PROPOSED DRAWINGS ELEVATIONS

MJP
 Job No: 24106 Sheet No: FSK011 Rev: B
 NE Elevation
 Drawn: POH Date: 14/08/2024

9-12 NEW COLLEGE PARADE, FINCHLEY ROAD, NW3 5EX

PROPOSED NORTH EAST ELEVATION. DRAWING no. 3001. 1:100@A3

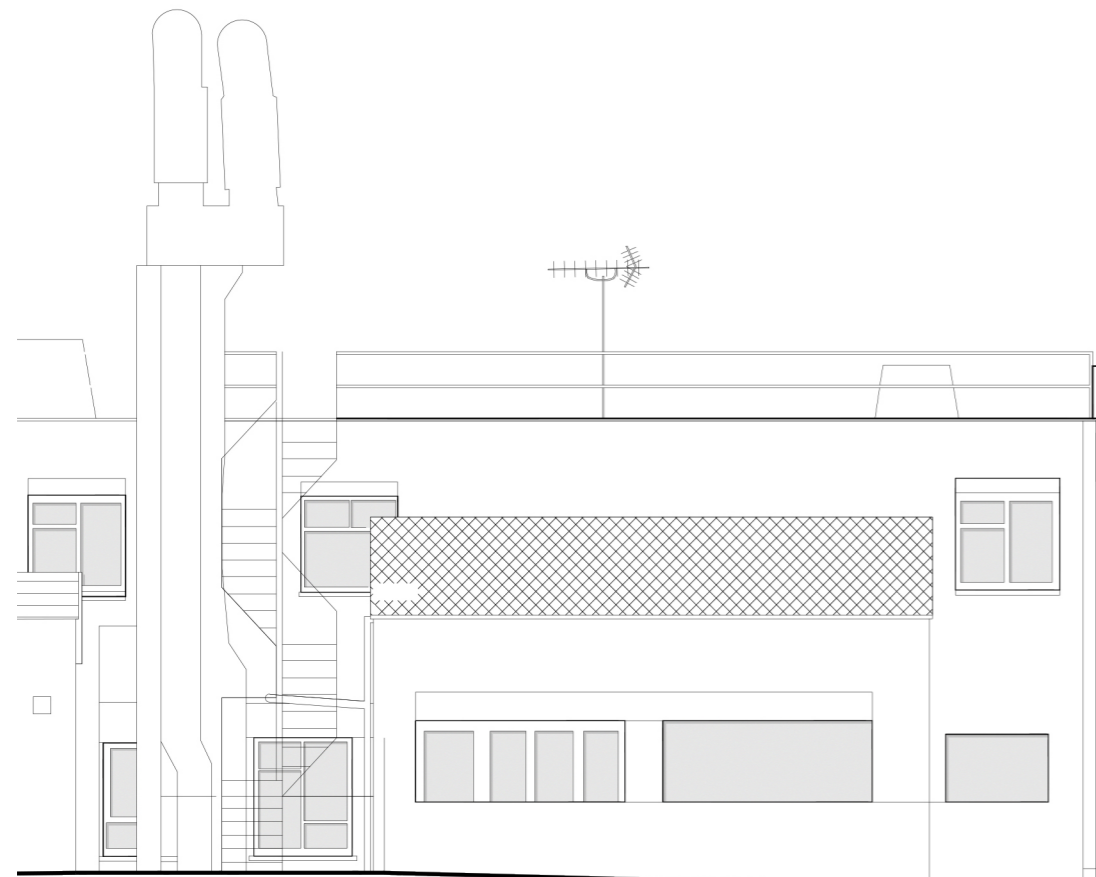
Where within 1.0m of boundary - two way 100% fire resistance rating required
External spread of fire to adjacent boundary will be addressed in accordance with ADB / BR 187

MJP: Green Wall to follow guidance as per Regulation 7 (2) and the best practice of ' Fire Performance of Green Roofs and Walls' published by the Department of Communities and Local Government (2013)

As a minimum (best practice), it is recommended

- The green wall should not be on ground level (to mitigate arson/threat) and to safeguard persons using the rear stair as egress.
- Persons/occupants using this rear stair will need to have sufficient spatial distance on ground level to move away from the threat of any falling debris/burning embers from the green wall. The spatial planning of any 'right of use/egress' may need to be confirmed that allows persons/occupants to move sufficiently away from this threat.

- Materials used in green walls to be non-combustible and meet European Classification A2-s1,d0 or A1
- Fire breaks within the wall system
- Management plan in place to address maintenance and minimize risks/threats. (i.e. irrigation systems to prevent the accumulation of dry, flammable material within green walls (credible fuel load) and the positioning of green walls to offset the risk of malicious activity/accidental fire start).

- The spaces/lobbies preceding entrance into the rear stairs from the internal (on all levels) – must be kept sterile and free of materials/storage and combustibles at all times.

- The rear stair must be kept sterile and free of materials/storage and combustibles at all times.
- No electrical equipment/sockets on the inside faces of the stair wall adjacent to the green wall.

- Insurers should be notified of the green wall approach.

The above requirements will be co-ordinated and detailed as the design progress/develops further as part of any future Building Control Application.

PROPOSED SOUTH EAST ELEVATION. DRAWING no. 3002

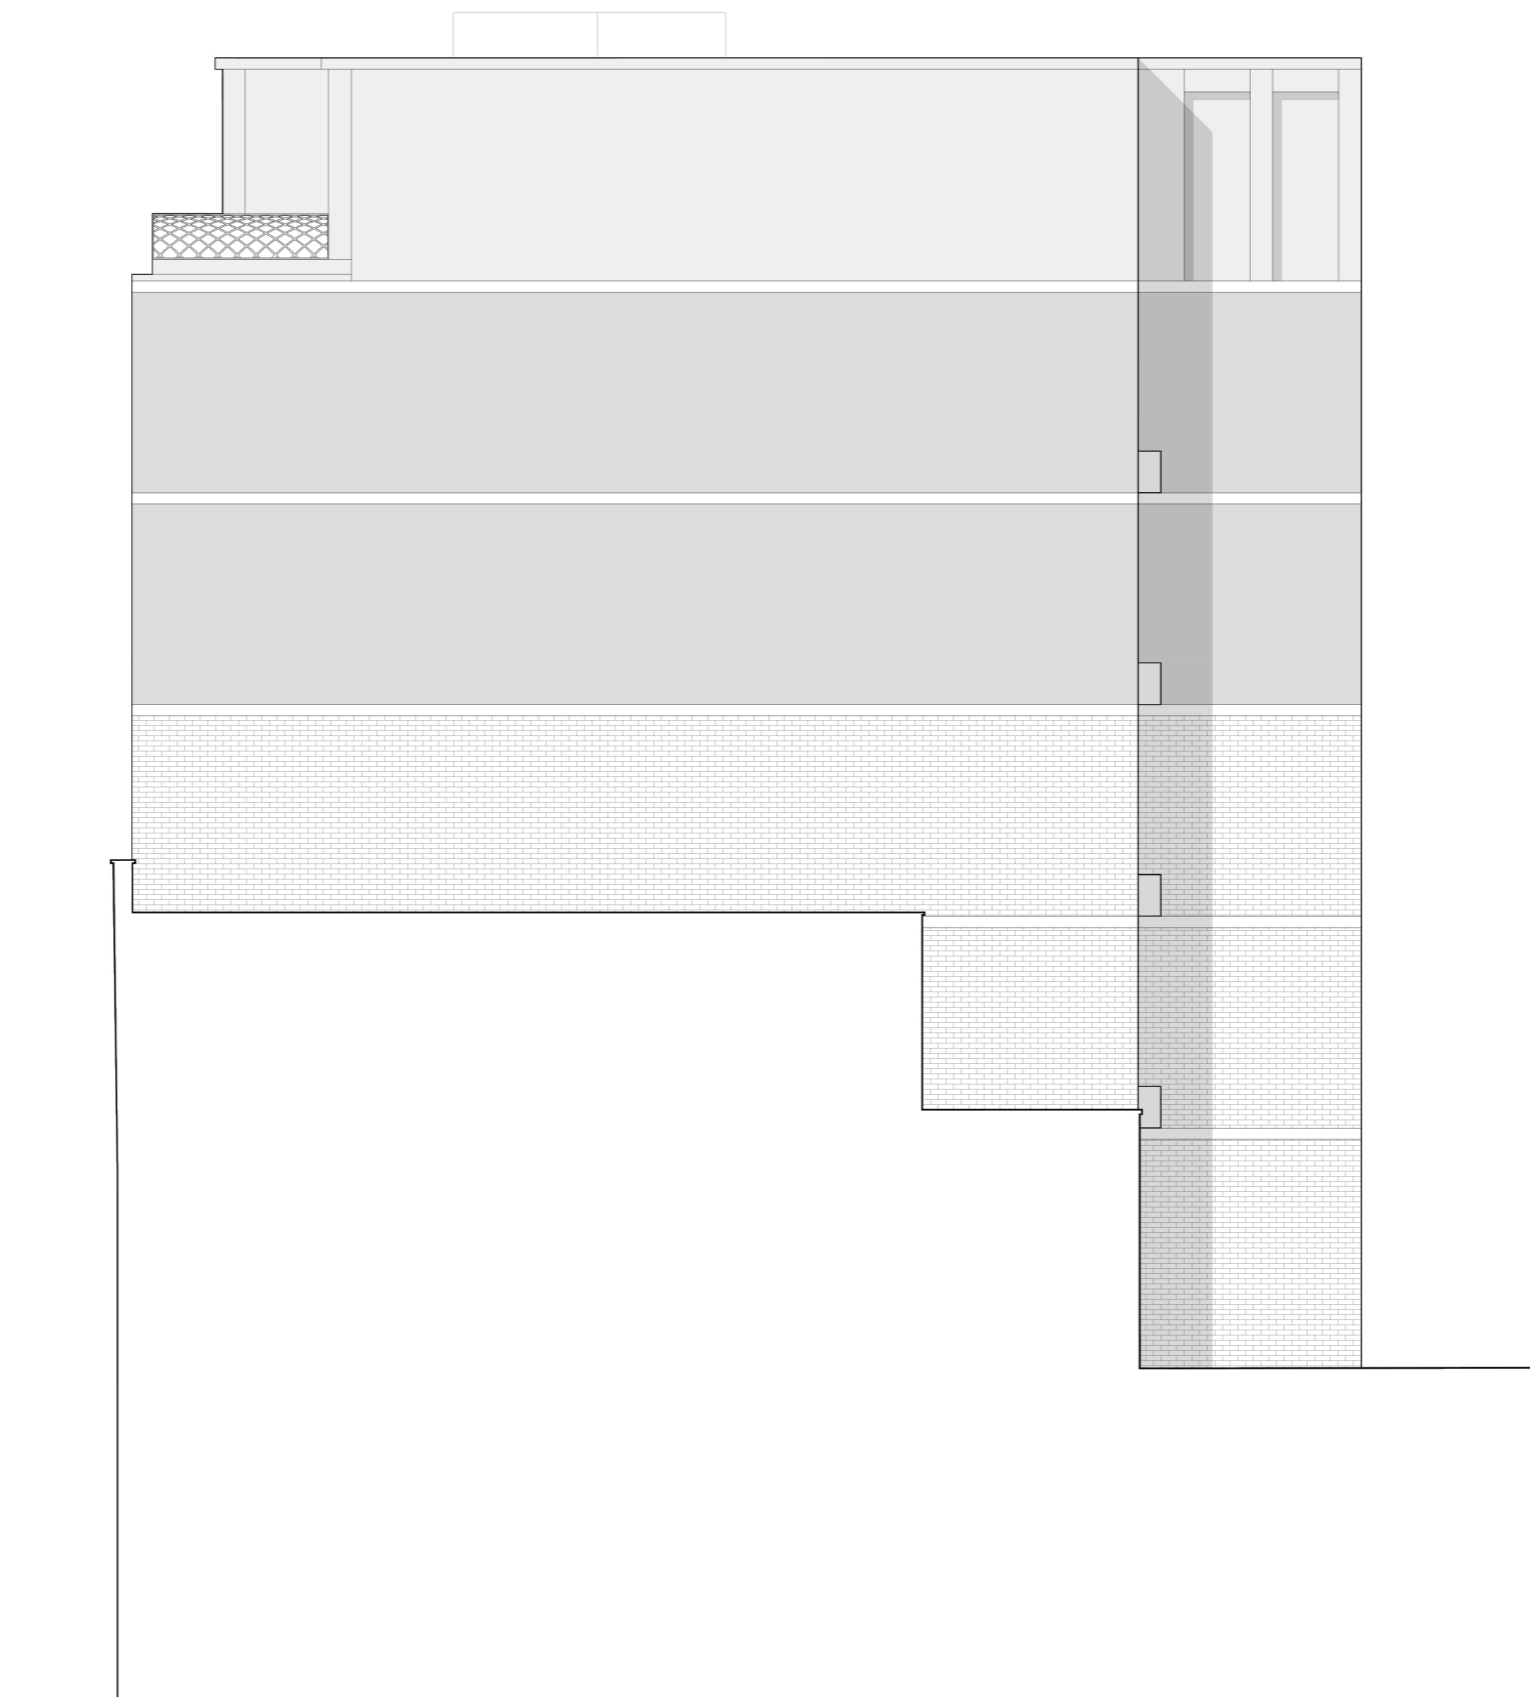
Where within 1.0m of boundary - two way 100% fire resistance rating required
External spread of fire to adjacent boundary will be addressed in accordance with ADB / BR 187

PROPOSED NORTH WEST ELEVATION. DRAWING no. 3003. 1:100@A3

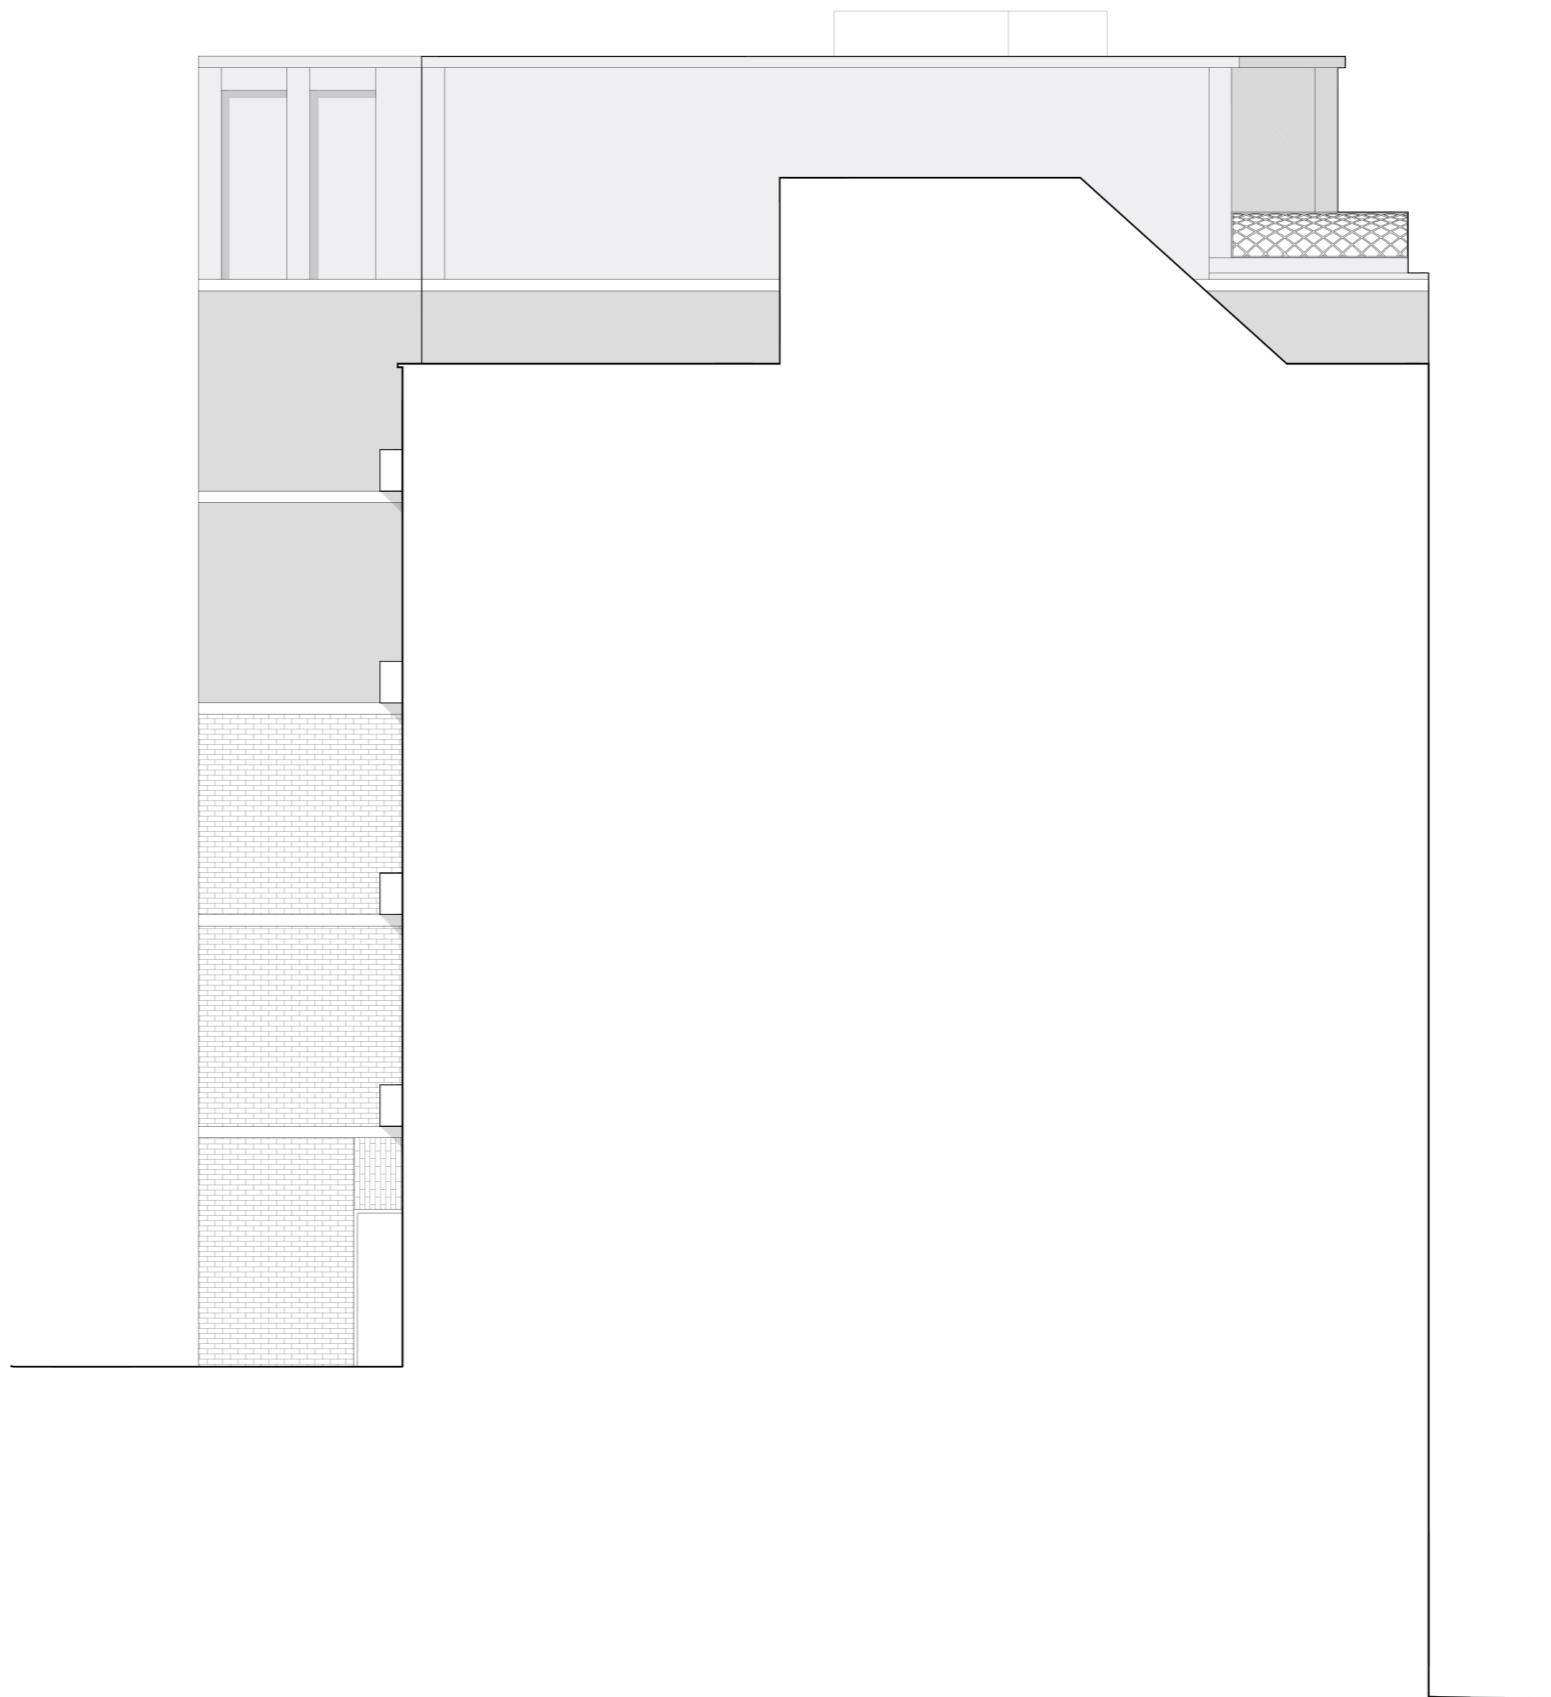
Where within 1.0m of boundary - two way 100% fire resistance rating required
